Contract #: 04-0120F4Cty: SF/ALA Rte: 80 PM: 13.2/13.9File #: 69.25B**QUALITY ASSURANCE -- NON-CONFORMANCE REPORT****Location:** Changxing Island, Shanghai, P.R. China**Report No:** NCR-000845**Prime Contractor:** American Bridge/Fluor Enterprises, a JV**Date:** 21-Sep-2010**Submitting Contractor:** Zhenhua Port Machinery Company, Ltd (ZPMC), Changxing Island**NCR #:** ZPMC-0807**Type of problem:**

Welding	Concrete	Other	
Welding	Curing	Procedural	Bridge No: 34-0006
Joint fit-up	Coating	Other	Component: East Tower Shaft Lift-5
Procedural	Procedural	Description: Missed MT transverse crack by QC

Reference Description: QA found a missed MT transverse crack after ZPMC had tested and accepted the weld in East Tower Lift 5

Subject: NCR No. ZPMC-0807

Description of Non-Conformance:

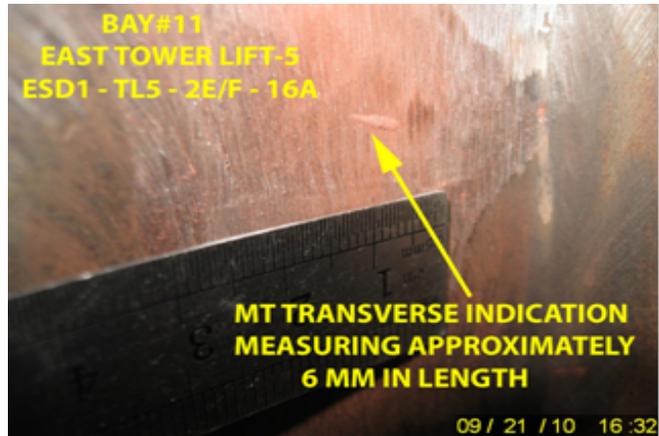
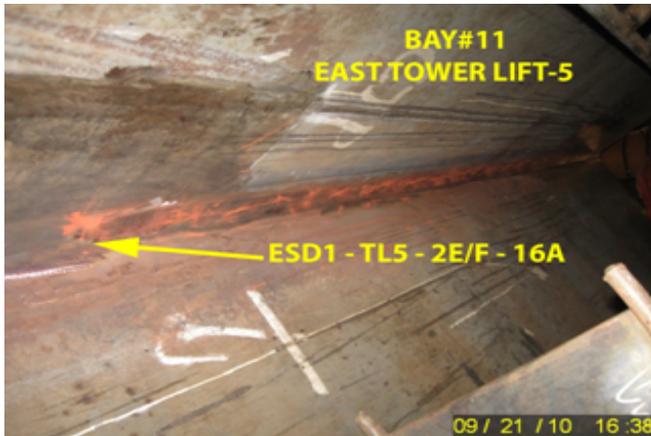
During Magnetic Particle Testing (MT) review of welds on grillage assembly of East Tower Lift-5, this Quality Assurance Inspector (QA) discovered the following issues:

- Transverse linear crack measuring approximately 6 mm in length.
- The member is identified as Grillage Plate.
- The weld is identified as ESD1-TL5-2E/F #16A.
- The weld is a Complete Joint Penetration (CJP) T-joint joining the Longitudinal grillage stiffener to Transverse grillage stiffener.
- The member is Non-Seismic Performance critical Member (SPCM).
- The member is located in Tower fabrication Bay # 11.

The Notice of Witness Inspection Number (NWIT) is 06730. The indication is located within the area that has been previously tested and accepted by ZPMC Quality Control (QC) personnel. As per the contract documents, ZPMC's QC personnel are required to perform 100% MT inspection of these welds.

Special Provisions Section 8.3 – “Quality Control (QC) shall be the responsibility of the Contractor. As a minimum, the Contractor shall perform inspection and testing of each weld joint prior to welding, during welding, and after welding as specified in this section and to ensure that materials and workmanship conform to the requirements of the contract documents.”

AWS D1.5 (02) Section 6.26.2 – “Welds that are subject to MT in addition to visual inspection shall have no cracks.

ZPMC repaired this indication immediately after it was found by grinding. The weld was then tested at the same time using MT and found to be free of defect by both ZPMC and the Department. Based on this immediate action and acceptable NDT results after, ZPMC requests closure of this NCR.

This proposed resolution is acceptable. The documentation received is sufficient and the Department concurs that Non-Conformance ZPMC-0807 is closed.

Contractor repaired the indication by grinding immediately after CT tested, and provided the NDT documentation to prove the indication have been removed satisfactorily.
